FEDERAL ENERGY REGULATORY COMMISSION
WASHINGTON, D.C. 20426

In Reply Refer To:
Office of Enforcement
Entergy Services, Inc.
Docket No. PA10-1-000
October 29, 2010

AUDIT REPORT

Docket No. PA10-1-000
October 29, 2010

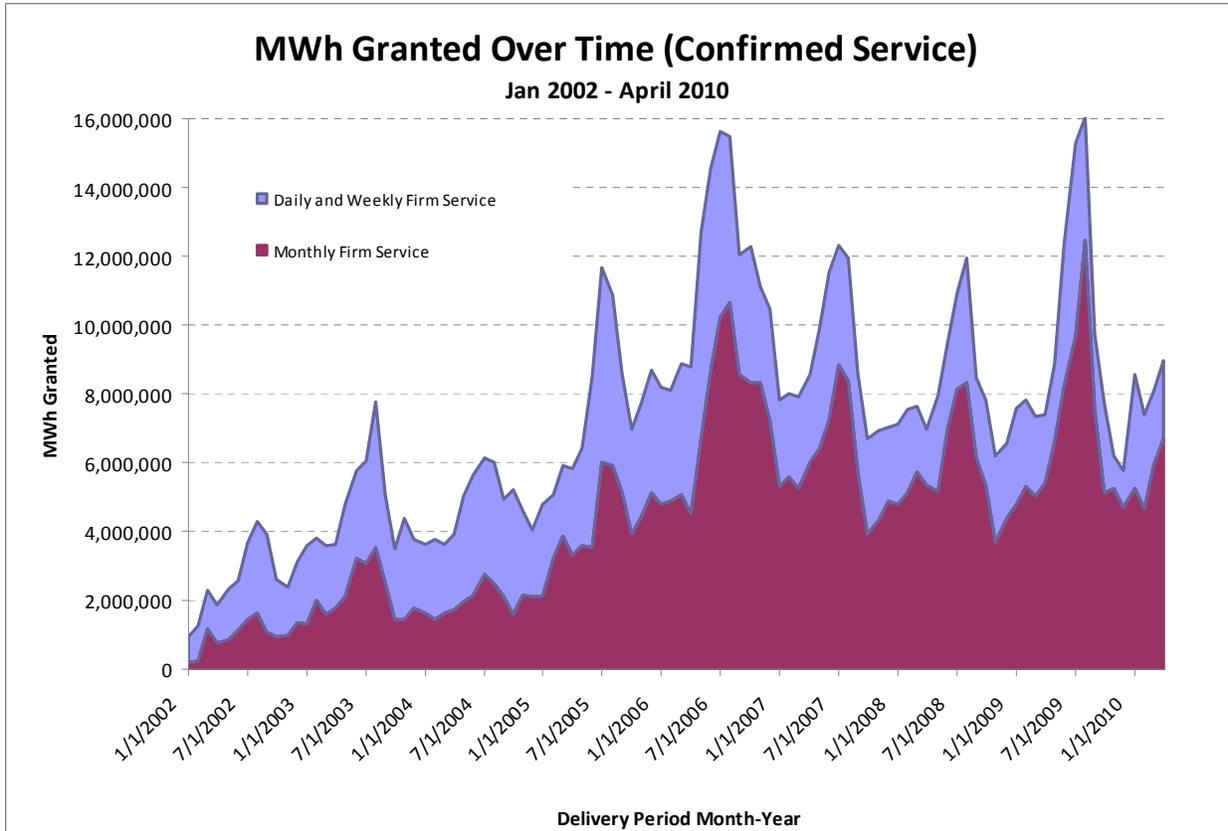
Under Order Nos. 888 and 890, public utilities are not required to use complex software such as AFC models to grant or deny transmission service. Public utilities that use more simplified procedures are less prone to “errors” because their calculations do not process nearly as much data nor are they updated as quickly. Yet, because of these limitations, they can also be less accurate. By contrast, Entergy’s AFC software has *4.5 million inputs per month* and hence is designed to provide an accurate and current depiction of the transmission system—yet, of course, it is also more prone to more errors because of the sheer number of inputs and calculations in the algorithms. Audit Staff did not consider this basic difference in its criticisms of Entergy.

In fact, the data is clear that Entergy has provided an increasing amount of transmission service on its system (in total megawatt hours) since the implementation of the AFC Process, as compared to prior years. Entergy has granted, on average, over 180,000 GWh of short-term service per year from 2004 through 2010 in the AFC process, compared to less than half that per year in 2002 and 2003.³³ Customers have confirmed only about 60% of this service. The chart

600 MW Error

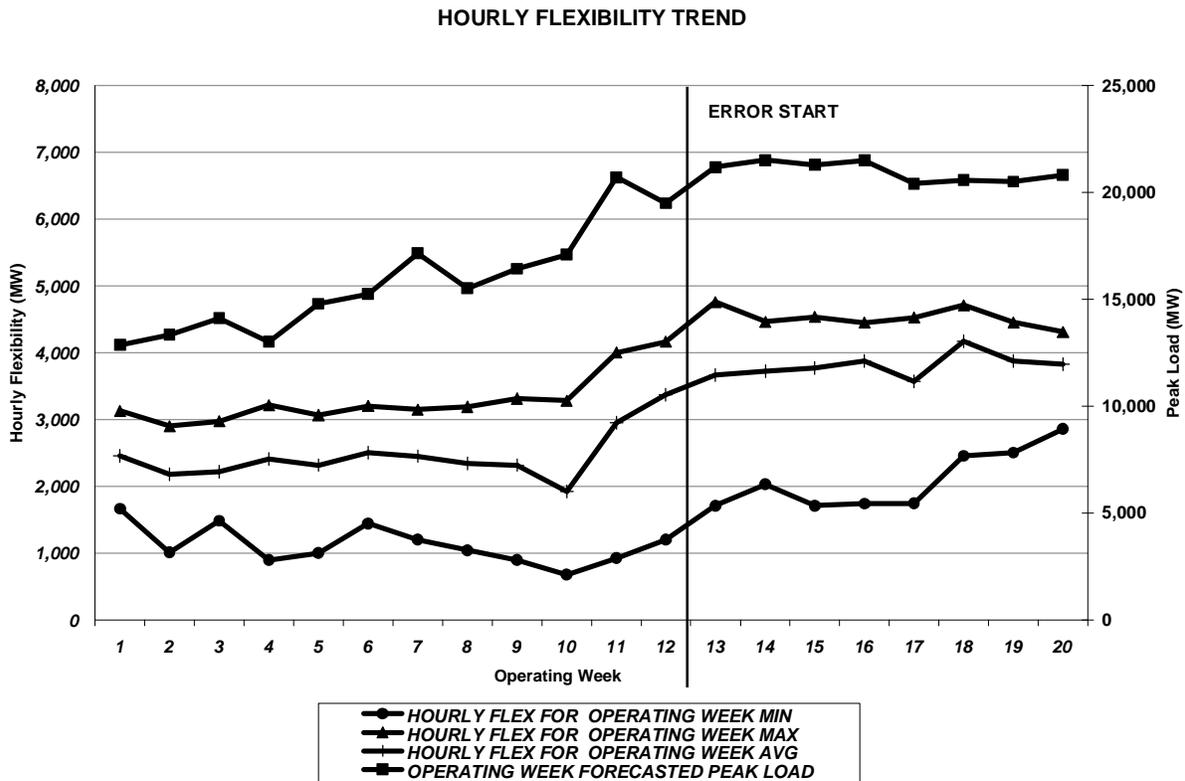
As this information shows, hourly flexibility requirements and load were trending upward before the error in hourly flexibility calculations was introduced. (The error did not affect daily flexibility calculations, and EMO does not specify an intra-hourly flexibility requirement.) From week 10 to week 11, for example, the daily average for hourly flexibility increased by 1,028 MW, while from week 11 to week 12 the amount of the increase was 423 MW. The levels of the increases between those weeks, each of which preceded introduction of the error, were greater than the 298 MW increase from week 12, without the error, to week 13, with the error. Thus, the differences in the weeks prior to the error and the week after the error did not appear to be inconsistent. Indeed, EMO’s conclusion was particularly reasonable given the increases in load that began the same week the error was first introduced into the flexibility calculation.
